ALERT SERVICE BULLETIN

429-14-15

MODEL AFFECTED: 429

SUBJECT: GOODRICH EXTERNAL HOIST

Figure 1. Lower limit for the 600 lb capacity hoists

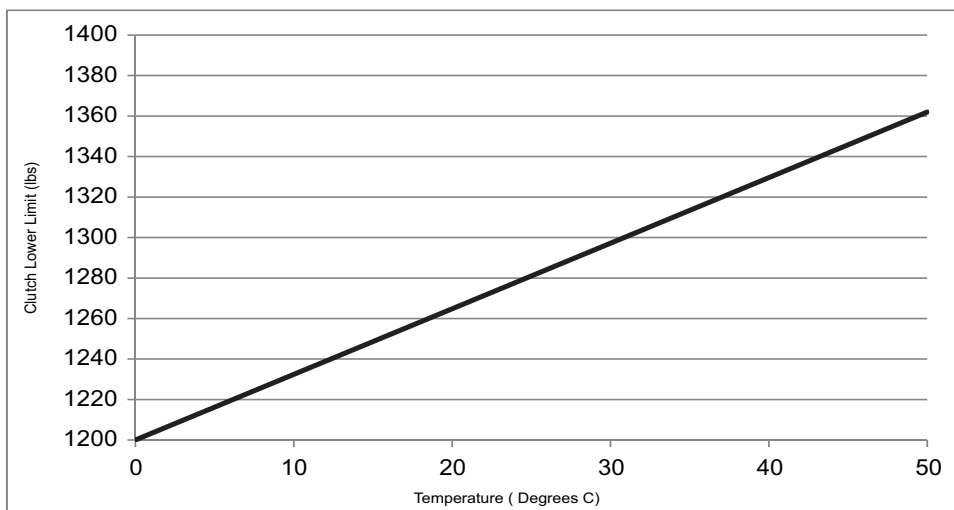
- a. If the test results indicate a value above the acceptable lower limits per Table 2, Figure 1 of the Goodrich ASB 44301-10-18, Revision 6, proceed with step 3.

- b. If the test results indicate a value below the acceptable lower limit per Table 2, Figure 1 of the Goodrich ASB 44301-10-18, Revision 6, remove the hoist from service before the next hoist operation.
